RECEIVED
OK'D BY: *Duc* OK'D BY: *DRP*
MAR 07 2007
RESUBMIT APPROVED AS NOTED
BY: *Duc* DATE: *3/30/07*

ALL MATERIAL (EXCEPT BOLTS) TO BE ASTM:		A709M-50W	
ALL WELDS TO BE MADE WITH ELECTRODES SERIES E XXX			
OPEN HOLES ARE FOR H.S. BOLTS AND ARE TO BE FREE OF BURRS AND SCALE			
BOLTS: 7/8" A325M TYPE III	OPEN HOLES: 24 UN	PAINT: SEE GN-1	
International Bridge & Iron Co. 90 Day Street Newington, CT. 06111			
VERMONT DOT SUNDERLAND BRIDGE FED. AID PROJ. NO.: BRP-0114 (2) CONTRACTOR: PETRICCA CONSTRUCTION CORP. ENGINEER: ROGER WHITCOMB			
For Approval	Revised	Issue to Shop	GENERAL NOTES
			Drawn by: K. E. Date: 02/28/07 Checked by: G. D. Date: 03/01/07
		Contract	Suffix Dwg. Number
		606	GN1

WELD TERMINATION AND COPING DETAILS FOR STEEL MEMBERS

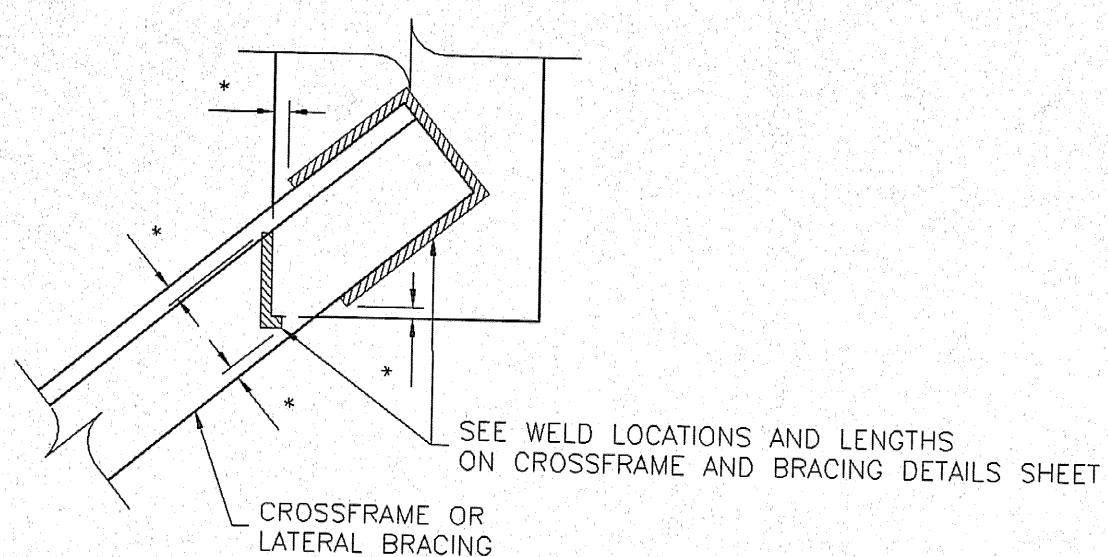
* NO WELD FOR 10 MIN. ²⁰18 MAX (EXCEPT MUST MAINTAIN 25 MIN. FROM EDGE OF FLANGE.)

* NO WELD FOR ⁶5 MIN. 13 MAX
